Subject: Resource Conservation and Recovery Act Ten-Year Renewal Application for the Waste Isolation Pilot Plant Hazardous Waste Facility Permit, Number NM4890139088-TSDF

RESOURCE CONSERVATION AND RECOVERY ACT TEN-YEAR RENEWAL APPLICATION FOR THE WASTE ISOLATION PILOT PLANT HAZARDOUS WASTE FACILITY PERMIT

Summary of Proposed Changes

Figure A1-28 Schematic of the RH Transuranic Mixed Waste Process for RH-TRU 72-B Shipping Cask

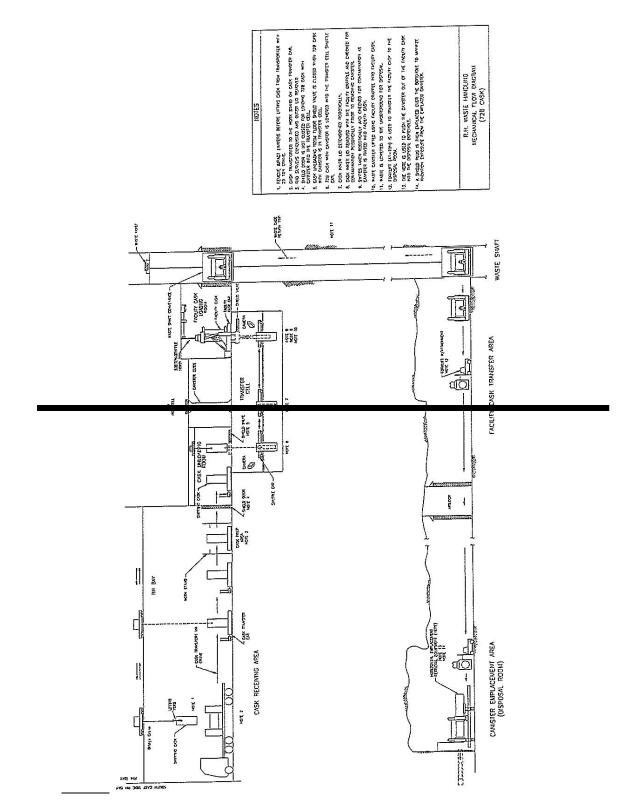
Renewal Application Section	Description of Change(s)	Discussion
Waste Process Flow		
Diagram for RH-TRU 72-		
B Shipping Cask		
Permit Figure A1-27	Moved to Attachment M, Figure M-41.	Streamline the Renewal Application and ensure its accuracy and
Surface and		readability.
Underground RH		
Transuranic Mixed		
Waste Process Flow		
Diagram for CNS 10-		
160B Shipping Cask		
Permit Figure A1-28	Figure removed.	Remove unnecessary detail that is not required by the New Mexico
Schematic of the RH		Hazardous Waste Regulations. The figure is not referenced in Permit
Transuranic Mixed		text, is of poor quality, and does not add value to the descriptive text
Waste Process for RH-		in Attachment A1; furthermore, there is not a comparable schematic in
TRU 72-B Shipping Cask		the Permit for the CH TRU mixed waste handling process.
Permit Figure A1-29	Figure removed.	Remove unnecessary detail that is not required by the New Mexico

Figure A2-8 Typical RH and CH Transuranic Mixed Waste Container Disposal Configuration

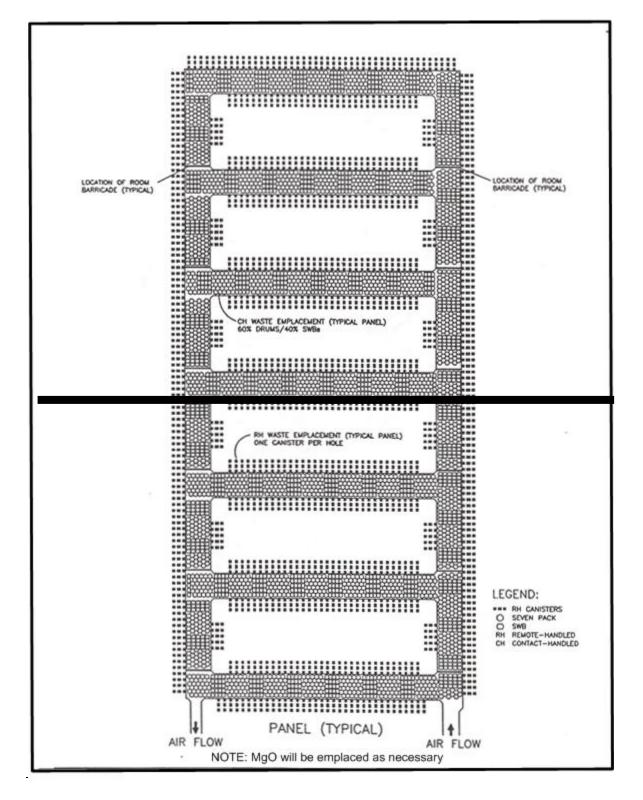
Permit Figure A2-7 Push-Pull Attachment to Forklift to Allow Handling of Waste Containers	Moved to Attachment M, Figure M-47.	Streamline the Renewal Application and ensure its accuracy and readability.
Permit Figure A2-8 Typical RH and CH Transuranic Mixed Waste Container	Moved to Attachment M, Figure M-48.	Streamline the Renewal Application and ensure its accuracy and readability.

Figure A2-13 Layout and Instrumentation - As of 1/96

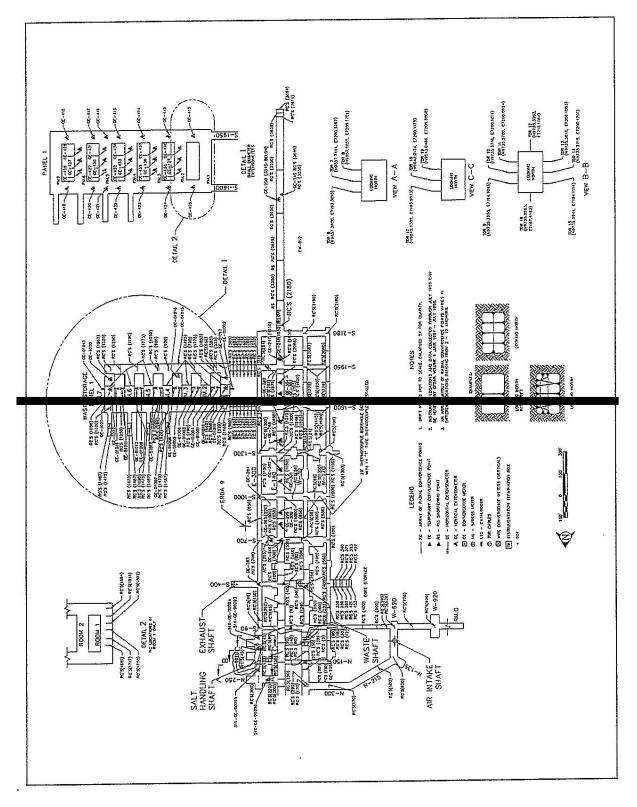
Section A2-5b(2) Geomechanical Monitoring	Removed reference to Figure A2-13.	Remove unnecessary information that does not support a Permit requirement and is not required by the New Mexico Hazardous Waste Regulations. The figure is being removed because it is of poor quality and the reference in the text of Attachment A2 is vague.
Monitoring	Added reference to the annual Geotechnical Analysis Report (GAR).	Ensure completeness and accuracy of the Renewal Application.
Section A2-5b(2(a) Description of the	Clarified that the borehole extensometer is installed "near," not "at," the center of each disposal room.	Ensure the accuracy of the Renewal Application.
Geomechanical Monitoring System	Changed "rock conditions" to "ground conditions."	Ensure the accuracy of the Renewal Application.
Section A2-5b(2)(b) System Experience	Removed obsolete historical information relative to system experience gained from the geomechanical monitoring of Panel 1; retained the last paragraph as part of Section A2-5b(2)(a). Clarified that WIPP excavations are "repository" excavations.	Remove obsolete information that no longer has any relevance in the Permit.

Figure A4-4a Typical Underground Transport Route Using W-30

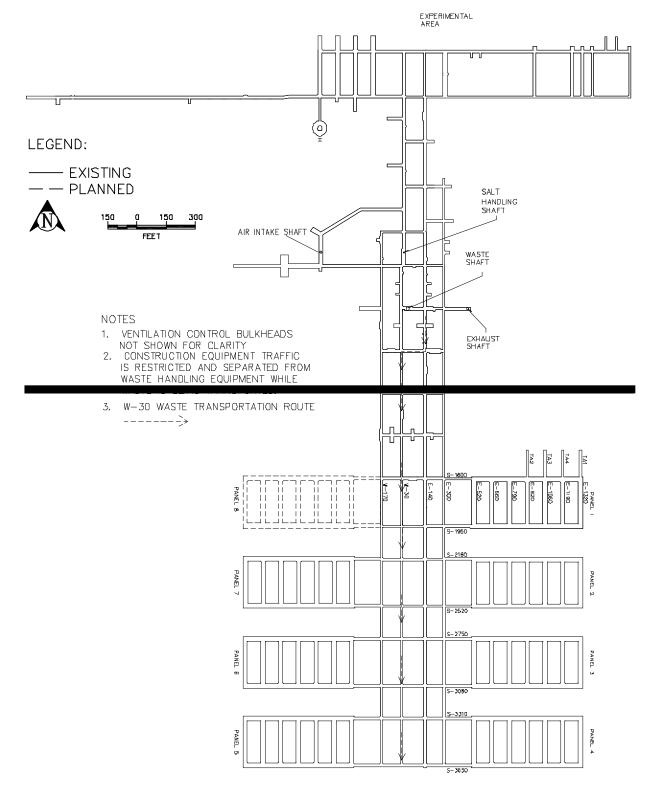
Permit Figure A4-4a Typical Underground Transport Route Using W-30	Combined with Figures A2-1, A4-4, G-1, and G-6 and moved to Attachment M, Figure M-43; changed title to "Repository Horizon and Underground Waste Transport Routes."	Streamline the Renewal Application and ensure its accuracy and readability.
Permit Figure A4-5 RH Bay Waste Transport Routes	Combined with Figures A1-14a and A1-17a and moved to Attachment M, Figure M-13; changed title to "RH Bay Ground Floor and Waste Transport Routes."	Streamline the Renewal Application and ensure its accuracy and readability.

Figure D-3 WIPP Underground Facilities

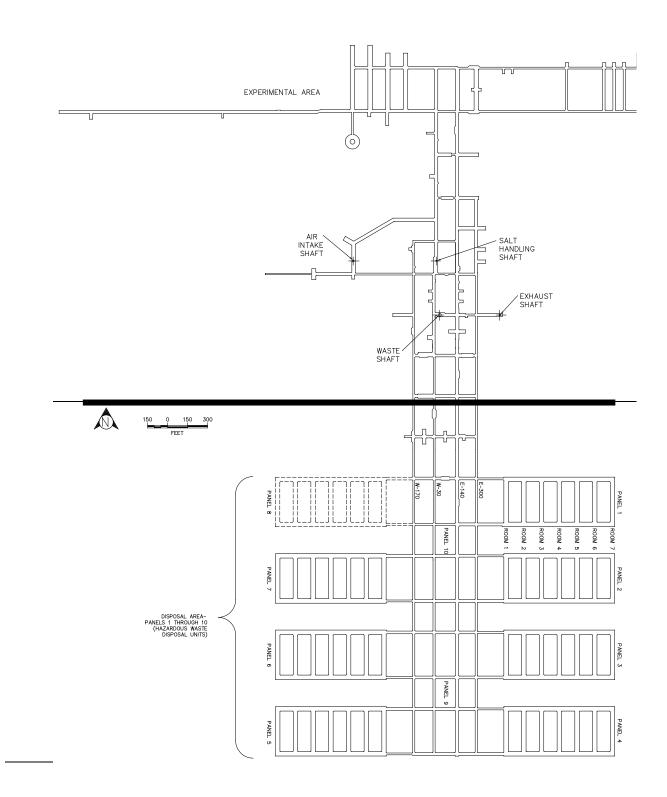
Figure D-3 WIPP Underground Facilities	Figure removed; the underground facility is depicted in Figure D-4. In addition, this figure is also depicted in Attachment M, Figure M-43.	Streamline the Renewal Application and ensure its accuracy and readability.
Figure D-4 Underground Escape and Evacuation Map	Renumbered figure from Figure D-4 to Figure D-3; updated text reference to figure, as appropriate.	Ensure the accuracy of the Renewal Application.
Figure D-5 Fire-Water Distribution System	Renumbered figure from Figure D-5 to Figure D-4; updated text reference to figure, as appropriate.	Ensure the accuracy of the Renewal Application.
Figure D-5-NFB Fire-Water Distribution	Renumbered figure from Figure D-5-NFB to Figure D-4- NFB; updated text reference to figure, as appropriate.	Ensure the accuracy of the Renewal Application.

Figure <u>D-6aD-5</u> RH Bay Evacuation Routes

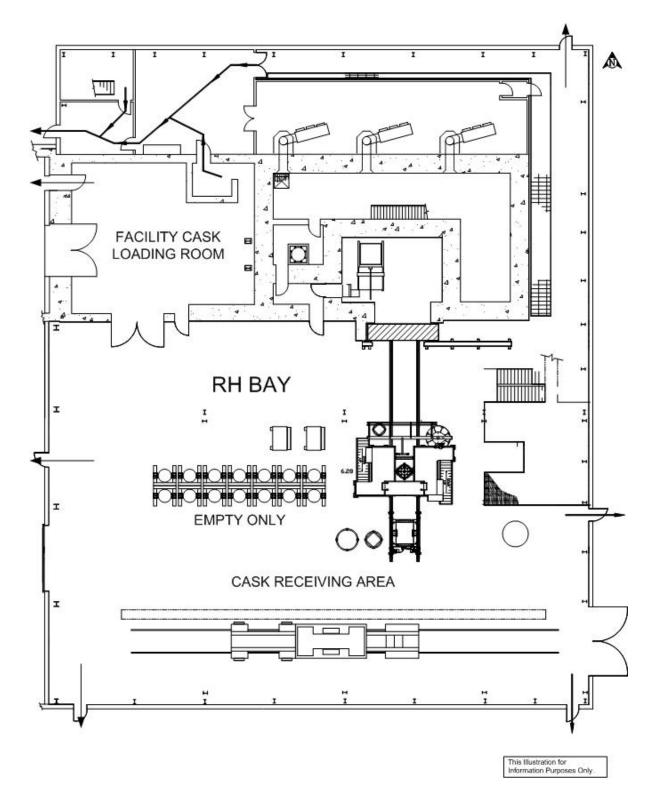
Figure D-6a RH Bay Evacuation Routes	Renumbered figure from Figure D-6a to Figure D-5; updated text reference to figure, as appropriate.	Ensure the accuracy of the Renewal Application.
Figure D-6b RH Bay Hot Cell Evacuation Routes	Renumbered figure from Figure D-6b to Figure D-6; updated text reference to figure, as appropriate.	Ensure the accuracy of the Renewal Application.
Figure D-6c Evacuation Routes in the Waste Handling Building	Renumbered figure from Figure D-6c to Figure D-7; updated text reference to figure, as appropriate.	Ensure the accuracy of the Renewal Application.
Permit Figure D-7 Designated Underground Assembly Areas	Figure removed; the underground assembly areas are depicted on Figure D-3. Change text references from Figure D-7 to Figure D-3.	Streamline the Renewal Application and ensure its accuracy and readability.
	Attachment I	E
	Inspection Schedule, Proc	ess and Forms
General	Global editorial changes described above.	Ensure accuracy and enhance the readability of the Renewal Application.

Figure G-4 Bulkhead and ROM Salt Locations

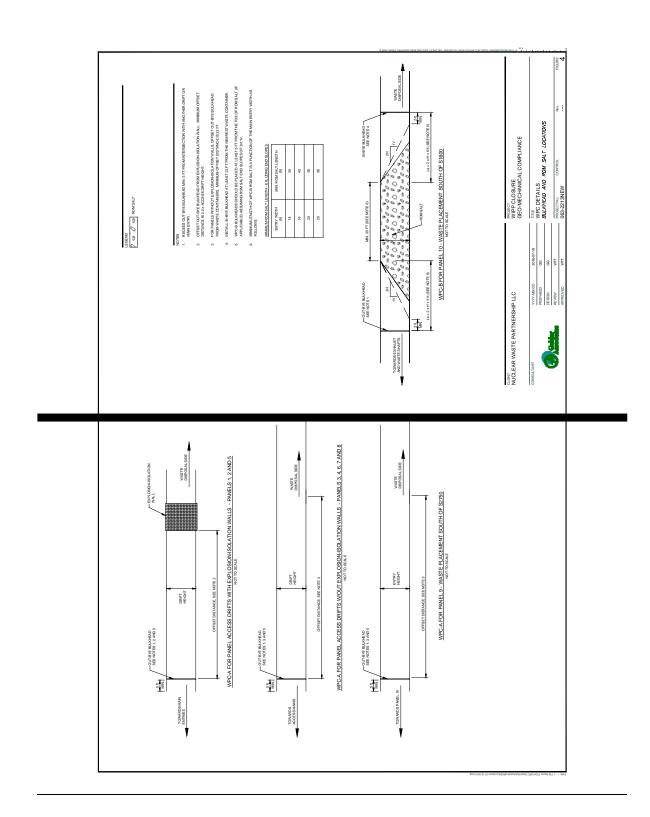
Permit Figure G-4 Bulkhead and ROM Salt Locations	Figure removed.	Streamline the Renewal Application and ensure its accuracy and readability; Figure G-4 is duplicative of a figure in Appendix G1-B.
Permit Figure G-4a Typical Substantial	Moved to Attachment M, Figure M-62.	Streamline the Renewal Application and ensure its accuracy and readability.

Figure G1-3 WPC Details – Bulkhead Front-View and Attachment Detail

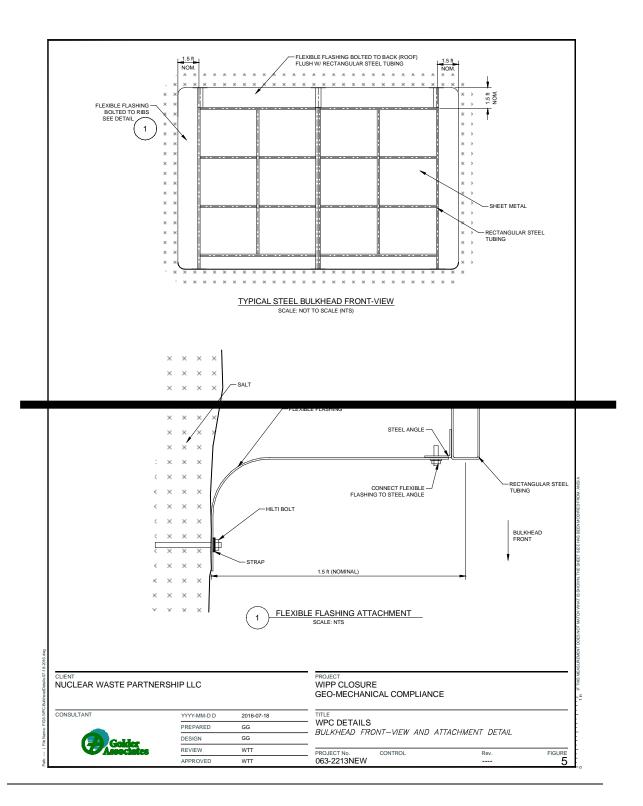
Renewal Application Section	Description of Change(s)	Discussion	
Permit Figure G1-3 WPC Details – Bulkhead Front View and Attachment Details	Removed figure.	Streamline the Renewal Application and ensure its accuracy and readability; this figure is duplicative with a figure in Renewal Application Attachment G1, Appendix G1-B.	
	Attachment G1, App	pendix A	
Tech	nical Specifications – WIPP Panel Closure, Waste	Isolation Pilot Plant, Carlsbad, New Mexico	
General	Global editorial changes described above.	Ensure accuracy and enhance the readability of the Renewal Application.	
Division 1	Added "Run-of-mine salt will also be used as part of the Panel 9 closure" in two places.	Ensure the completeness and accuracy of the Renewal Application; the revision reflects closure for Panels 3, 4, 5, and 6 allowed by Attachment G.	
Section 01010 Part 1 Section 1.2 Scope of Work	 Added the following two sub-bullets to the "Perform the following operations for the main entries between Panels 9 and 10" bullet: Prepare the surfaces for the ROM salt placement Place ROM salt material in multiple layers 	Ensure the completeness and accuracy of the Renewal Application by clarifying the process used for placing ROM salt between Panels 9 and 10.

Figure L-7 As-Built Configuration of Well WQSP-1

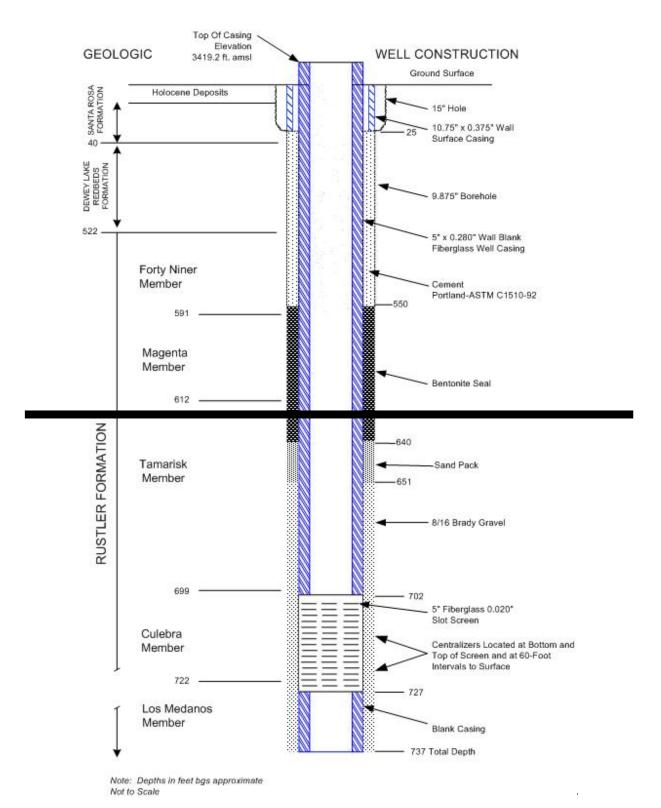
Renewal Application Section	Description of Change(s)	Discussion
Permit Figure L-6 Detection Monitoring Well Locations	Moved to Attachment M, Figure M-69.	Streamline the Renewal Application and ensure its accuracy and readability.
Permit Figure L-7 As-Built Configuration of Well WQSP-1	Moved to Attachment M, Figure M-70.	Streamline the Renewal Application and ensure its accuracy and readability.
Permit Figure L-8 As-Built Configuration of Well WQSP-2	Moved to Attachment M, Figure M-71.	Streamline the Renewal Application and ensure its accuracy and readability.
Permit Figure L-9 As-Built Configuration of Well WQSP-3	Moved to Attachment M, Figure M-72.	Streamline the Renewal Application and ensure its accuracy and readability.
Permit Figure L-10 As-Built Configuration of Well WQSP-4	Moved to Attachment M, Figure M-73.	Streamline the Renewal Application and ensure its accuracy and readability.
Permit Figure L-11 As-Built Configuration of Well WQSP-5	Moved to Attachment M, Figure M-74.	Streamline the Renewal Application and ensure its accuracy and readability.
